**From:** Larry Teahon <Larry\_Teahon@cameco.com>  
**Sent:** Tuesday, April 28, 2015 1:14 PM  
**To:** Lancaster, Thomas  
**Cc:** Doug Pavlick; Robert Tiensvold; Sabrina Fox; Larry McGonagle  
**Subject:** MET Data RAI #2  
**Attachments:** Table 2.5-14 Marsland MET Station Description Rev 1.pdf

Letter dated November 19, 2014 stated that during NRC staff review of the MEA Technical Report it was identified that certain areas under the Meteorology Section needed additional information. Request for Additional Information (RAI) #2 requested the following;

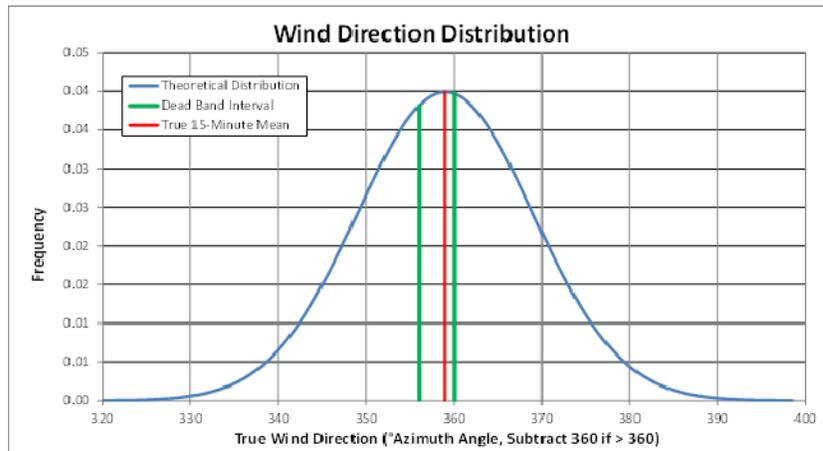
1. The height above ground level that wind speed, wind direction, temperature and relative humidity measurements are made;
2. A drawing or photograph of the meteorological tower showing the instrumentation location relative to the tower lattice work, including the lengths of the booms;
3. An evaluation which would establish that the wind sensor electrical range limitation to 356 degrees azimuth does not affect meteorological data fidelity.

3. The most commonly used wind direction sensors employ a circular potentiometer to generate electrical signals that represent the azimuth angle (degrees counter-clockwise from North). Although the mechanical range of these sensors is 360°, the electrical range is necessarily restricted to less than 360°. The potentiometer cannot function without this "dead band" between the high and low resistance extremes. For the Met One 034B wind sensor, the dead band is 4°. Even though the wind vane is free to rotate continuously, the potentiometer only generates signals ranging from 0 to 356°. If the true instantaneous wind direction is greater than 356° but less than 360° the signal will indicate 356° (full-scale value), resulting in a negative bias for wind directions in the dead band.

Probability theory can be used to analyze the expected degree of bias in recorded wind directions. While the maximum instantaneous bias would be -4° based on the above description (i.e., when the true wind direction is just below 360°), the maximum average bias during the data logging interval is much closer to zero. The reason is that the wind direction fluctuates naturally throughout the logging interval. This fluctuation is quantified as sigma theta. Typically, the logger scan rate is every 1 to 5 seconds but the scanned directions are vector averaged over each logging interval (e.g., 15 minutes or 1 hour). Only the averaged directions are recorded. Shown below are a typical dead band interval, hypothetical 15-minute mean wind direction of 359°, and overall data distribution during this logging interval based on a sigma theta of 10°.

In the northern Great Plains, typical 15-minute values for sigma theta range from 5° to 20° and higher. This means that even when the true 15-minute average wind direction falls within the instrument dead band, the instantaneous wind direction will statistically fall outside the dead band for most of the logging interval. During these times the sensor will indicate the correct wind direction (subject to instrument accuracy), thus lowering the overall average bias in the wind direction signal. Using the example graphed above, if the true 15-minute average is 359°, sigma theta is 10°, and wind directions are normally distributed, the sensor will read full scale less than 16% of the time. While at full scale, the expected average sensor error is -2.02°. Therefore, the average bias throughout the 15-minute interval is  $0.16 \times -2.02 = -0.32^\circ$ .

Sigma theta is the standard deviation of the horizontal wind direction values scanned during the logging interval. Even when the 15-minute average wind direction falls outside the instrument dead band, some error may be introduced due to this standard deviation in wind directions. Higher sigma theta values will lead to lower peak errors, but with more dispersion as shown in the graphic below.
